ADDENDUM NO. TWO

PUBLIC WORKS VEHICLE MAINTENANCE FACILITY

CITY OF SOCIAL CIRCLE, GEORGIA

PROJECT NO. 242774

GENERAL NOTES - STRUCTURAL:

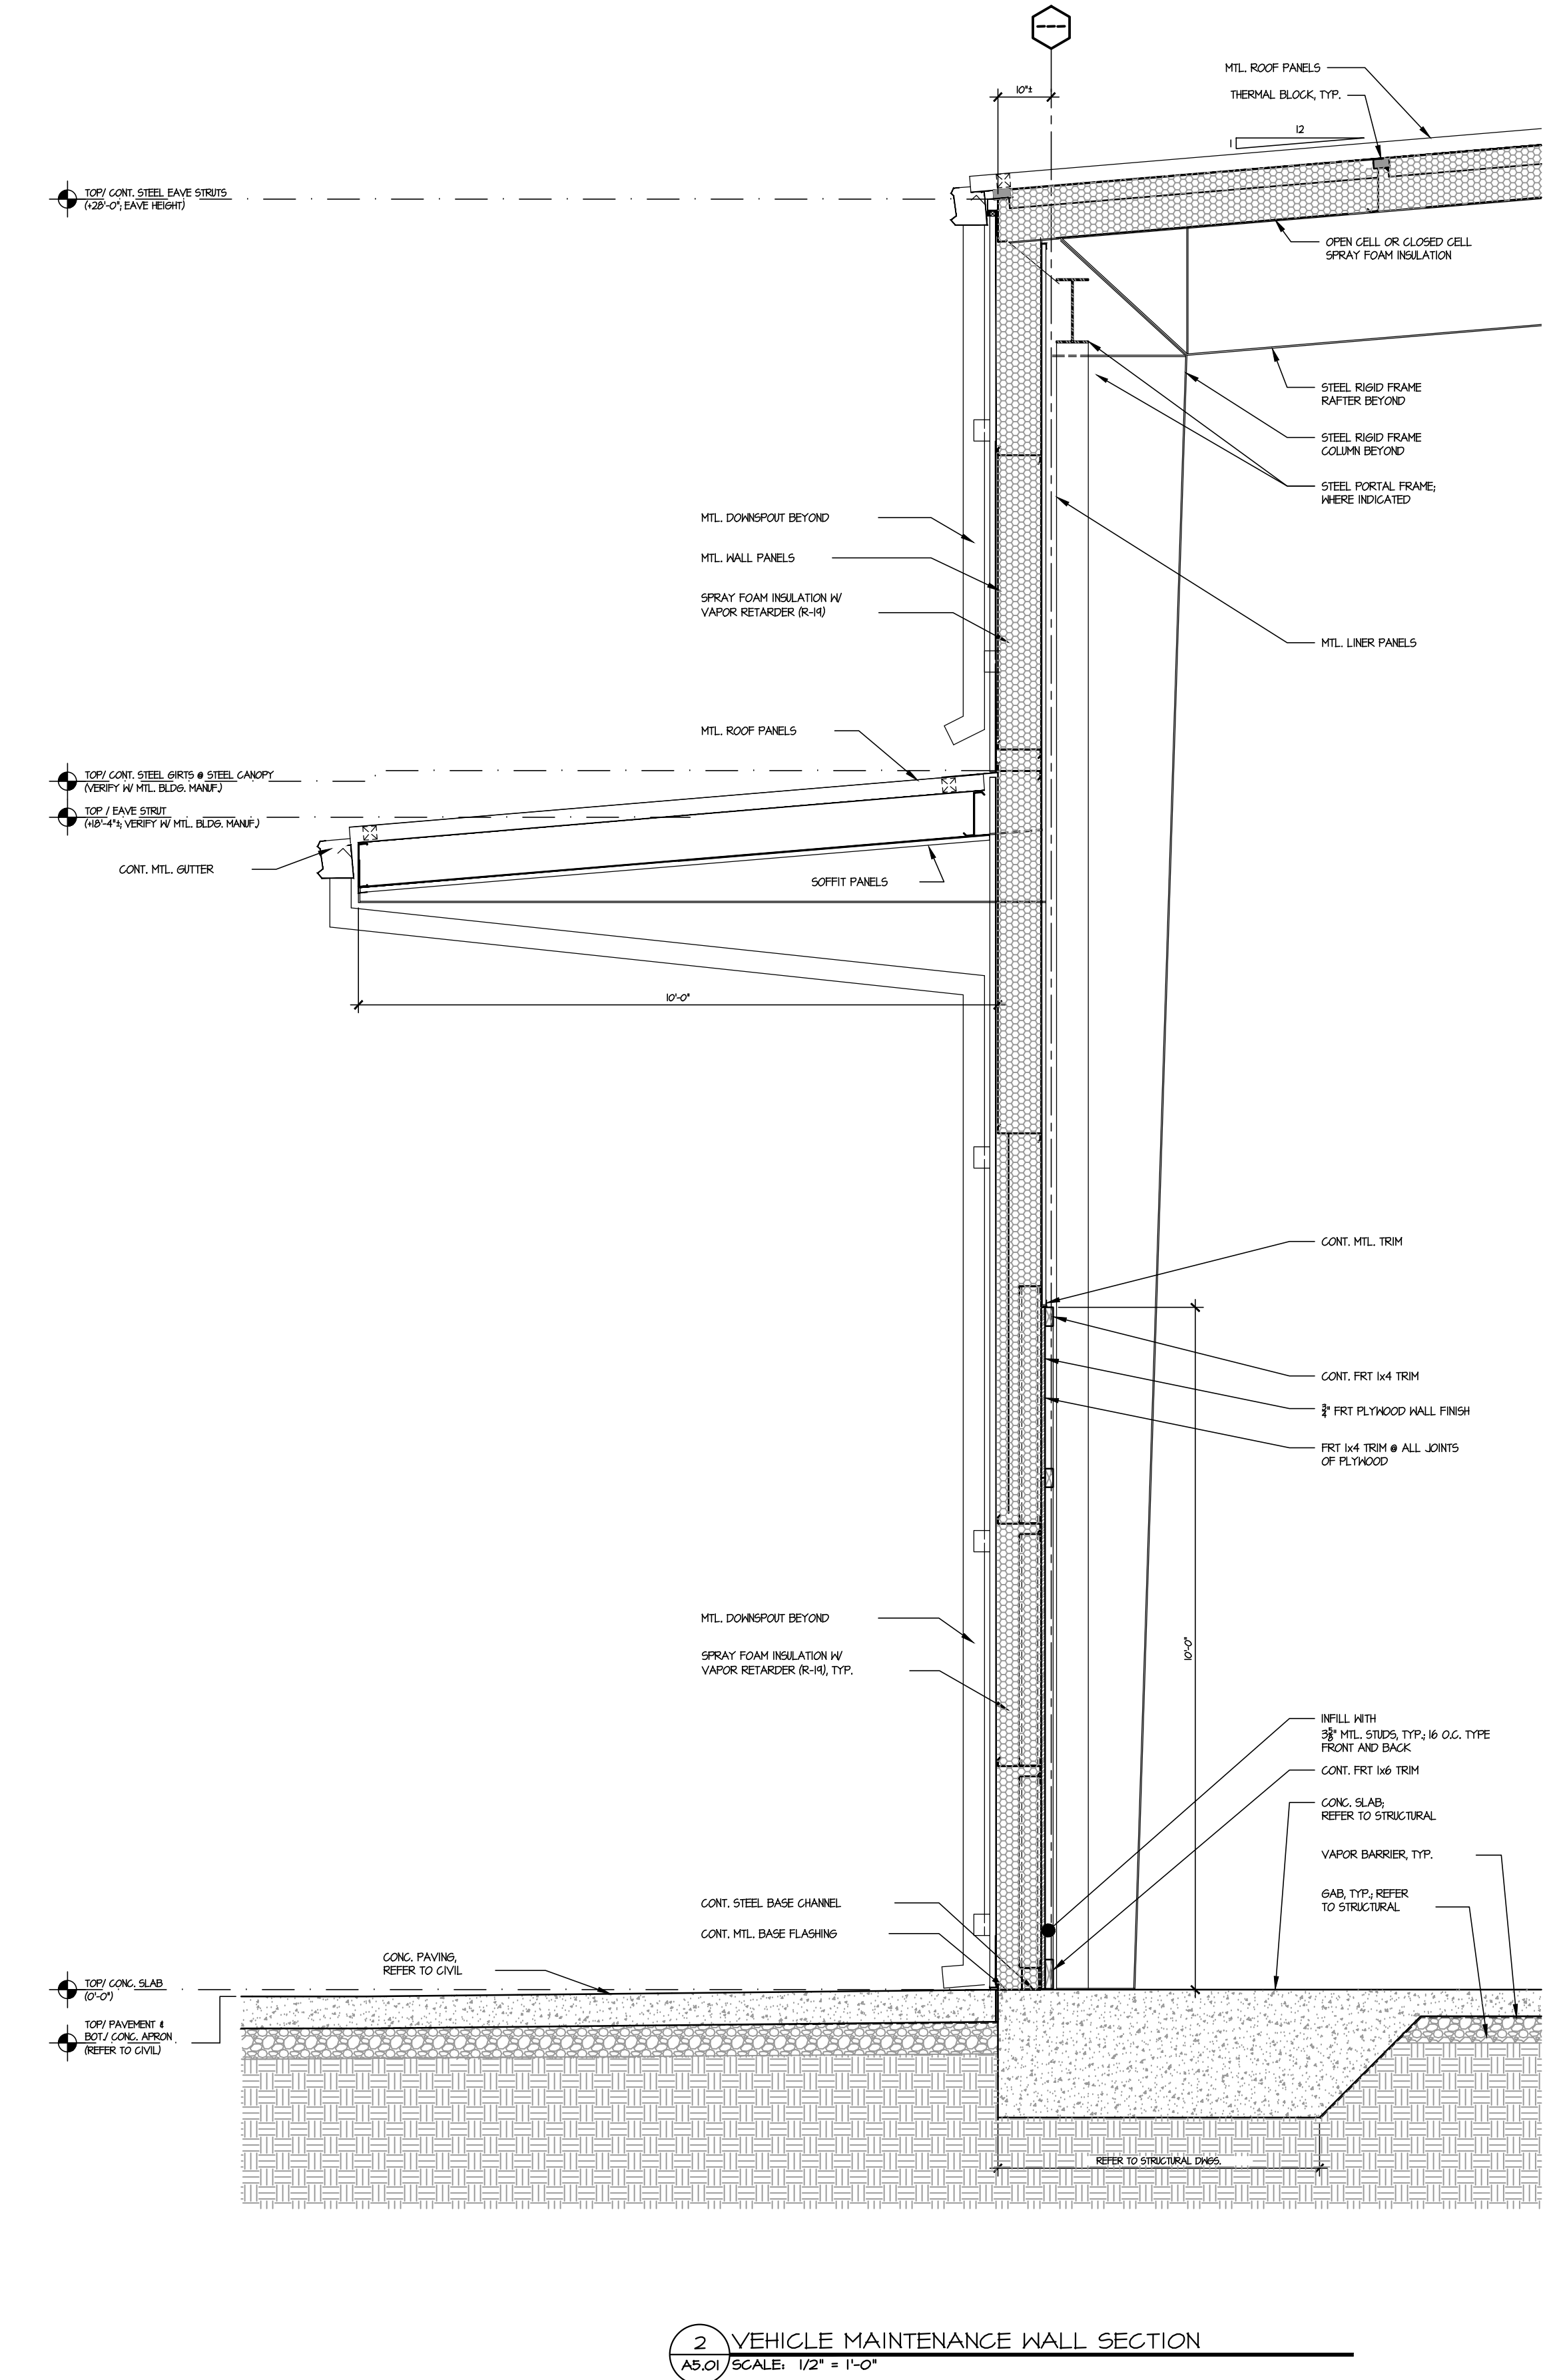
- 21. IBC 2024 was adopted statewide in GA as of Jan 2026, S0.01 reference IBC 2018. Please confirm this is grand fathered in on 2018.**

- 22. S0.01 – please confirm note 10 is accurate and requires structural jambs and headers for roll up and overhead doors. Sizes to be per PEMB design to fit within wall cavity.**

IBC 2024 is correct. Revised sheet S0.01 to be issued will indicate IBC 2024.

Note 10 is correct.

SHEET NUMBER
S2.01

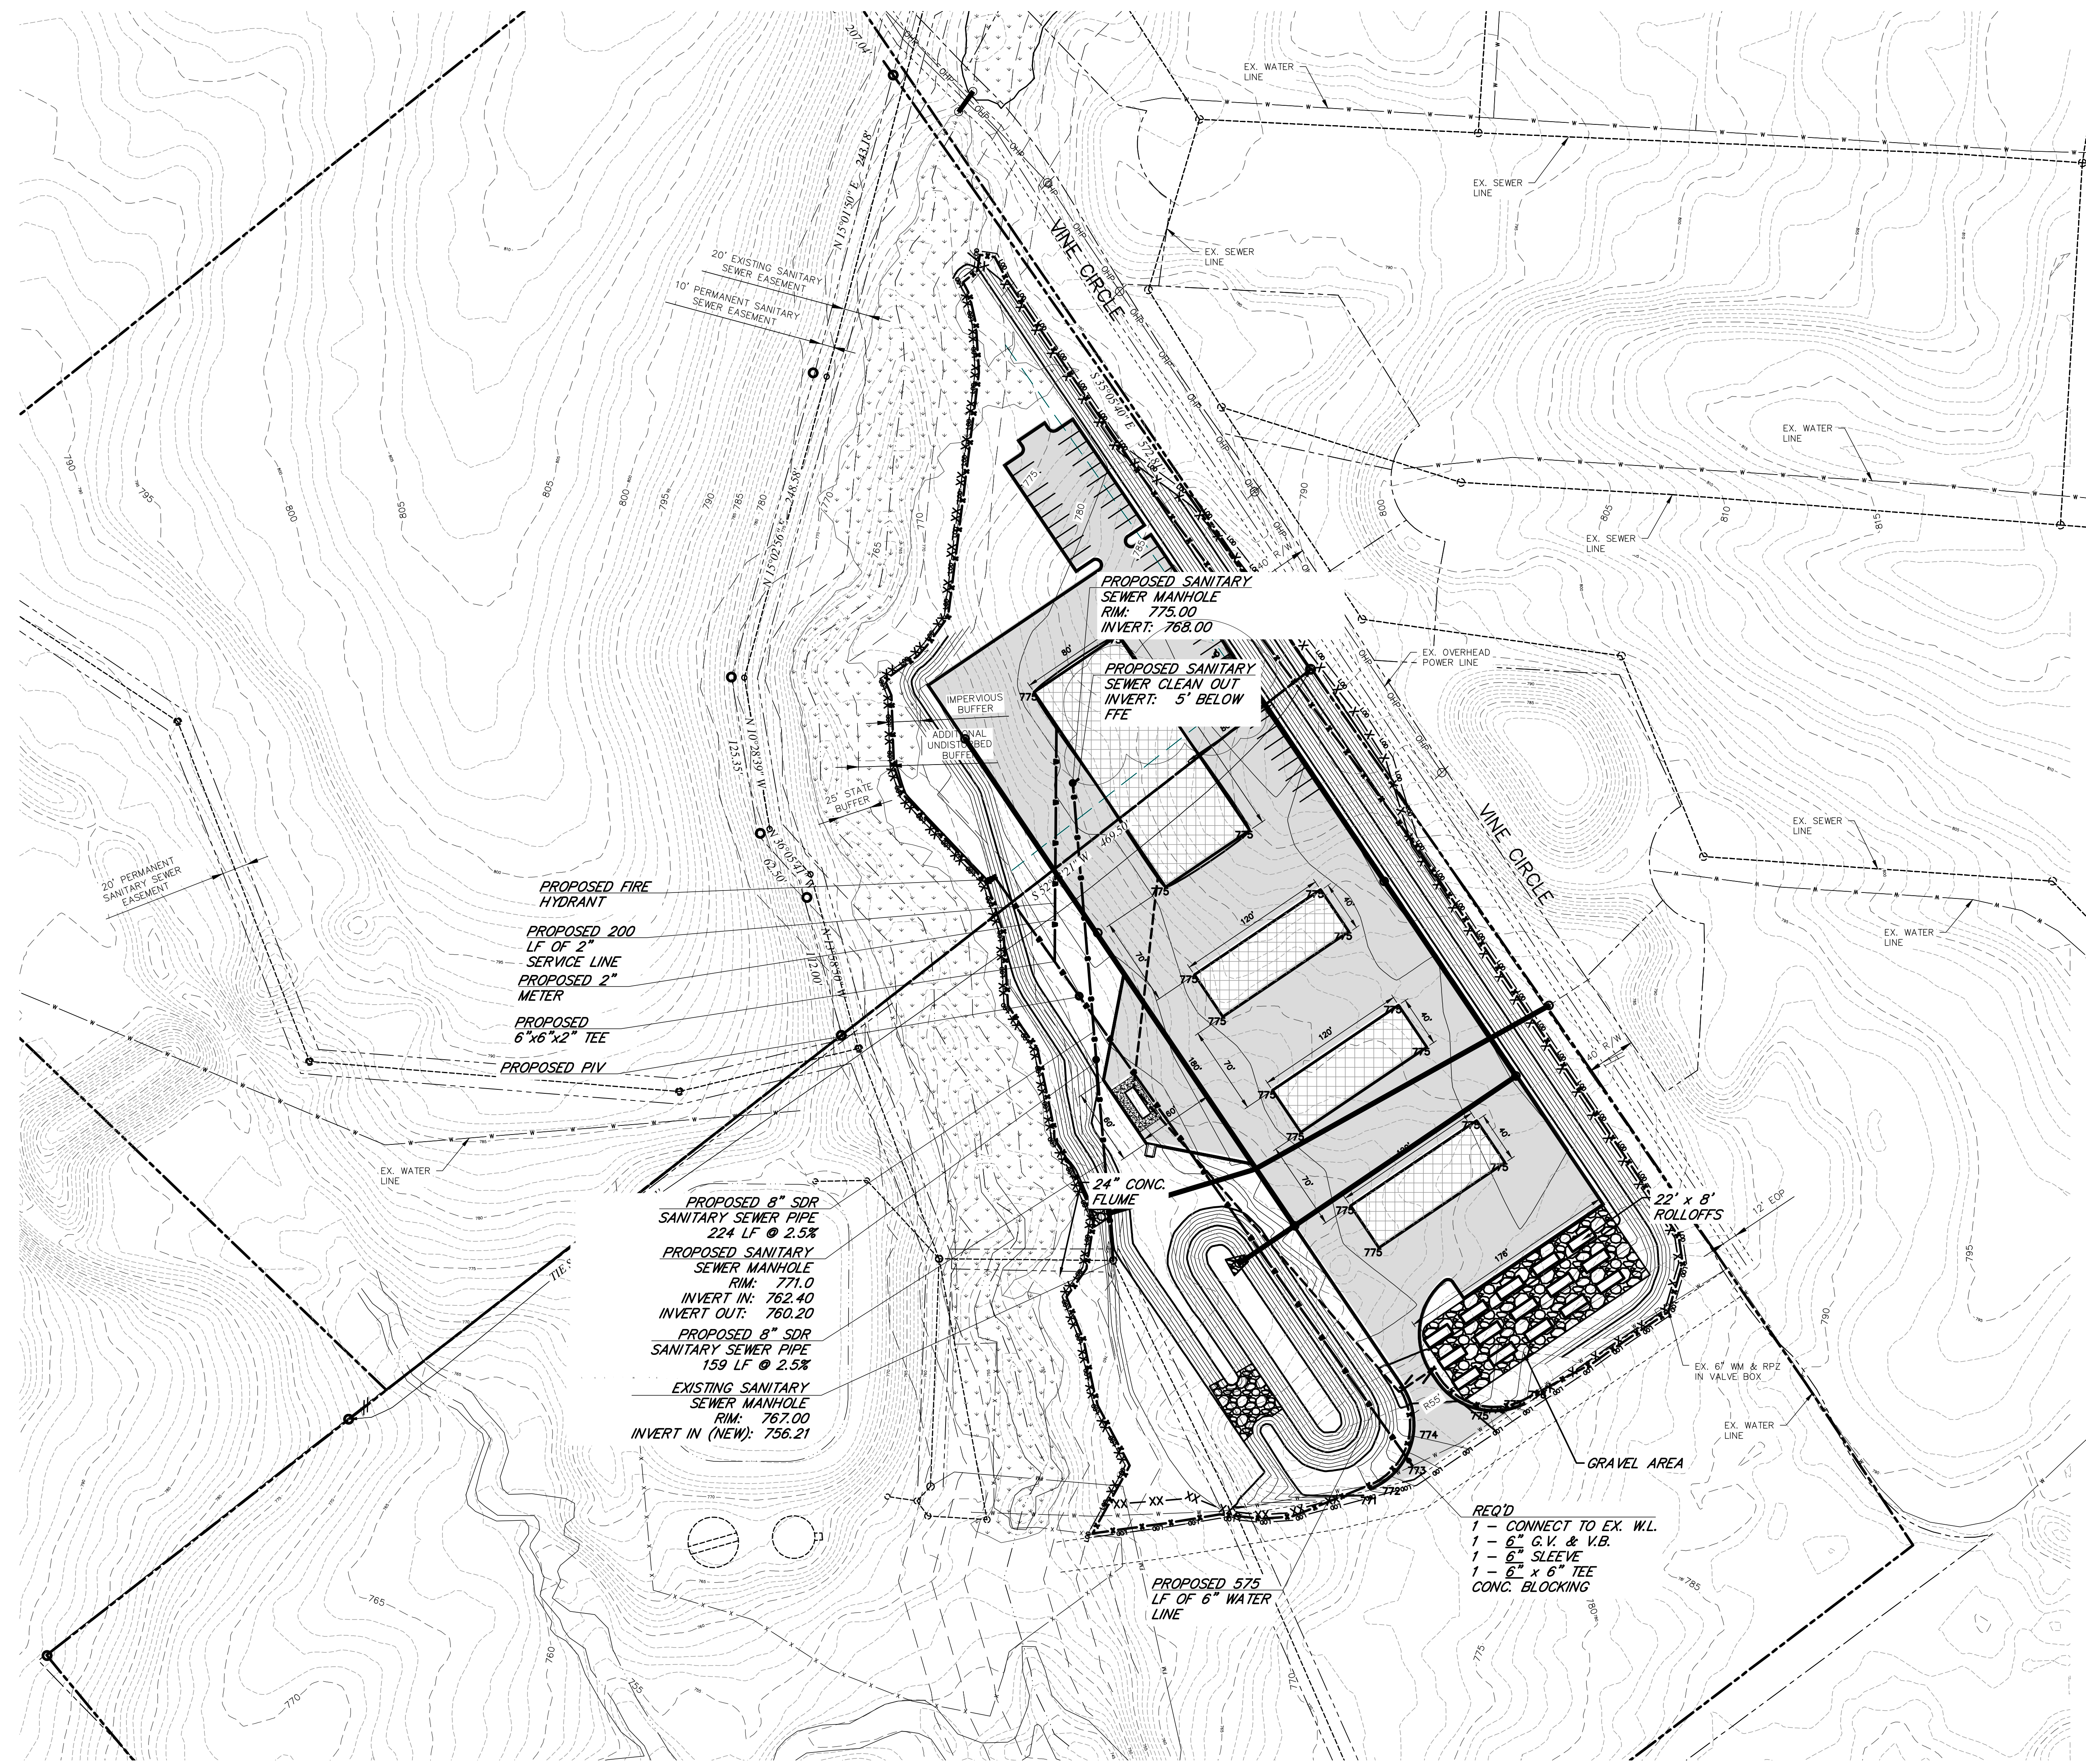
- 6. S2.01 has 8 EA F7 spread footers labeled but schedule at top of page only lists F4, F6, & F8. I just wanted to verify if that footer needed to be F7 or F8, and if F7, verify that it's 7' x 7' x 2'. –**

F7 footings to be 7'x7'x2'. Revised sheet S2.01 to be issued.

SEWER PIPE BEDDING DETAIL
N.T.S.

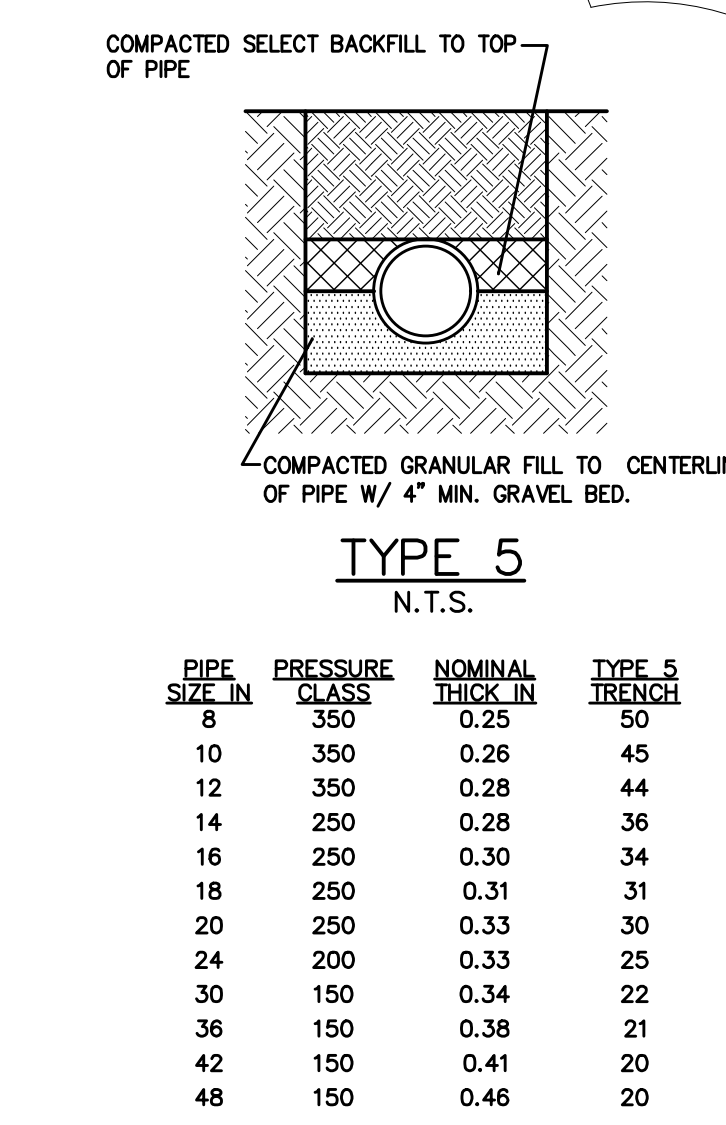
44. Please provide storm and sewer bedding details. Sewer line in wetland detail provided but no proposed sewer is shown in the wetland.

Pipe bedding detail has replaced the sewer line in wetland detail on sheet E-7. See revised sheet E-7.

CLEANOUT DETAIL
N.T.S.

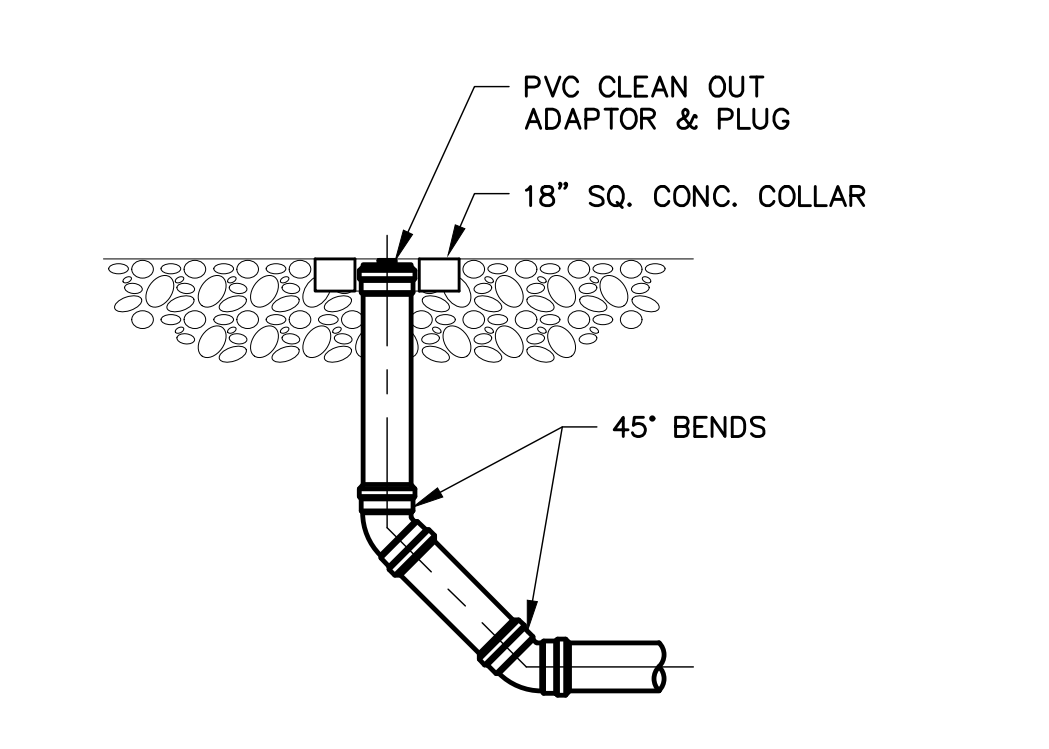
43. Do you want us to include a sanitary sewer cleanout going to the maintenance building from the proposed manhole?

The label shown on sheet E-6 has been updated to reflect a cleanout at the location just outside of the building. See revised sheet E-6.
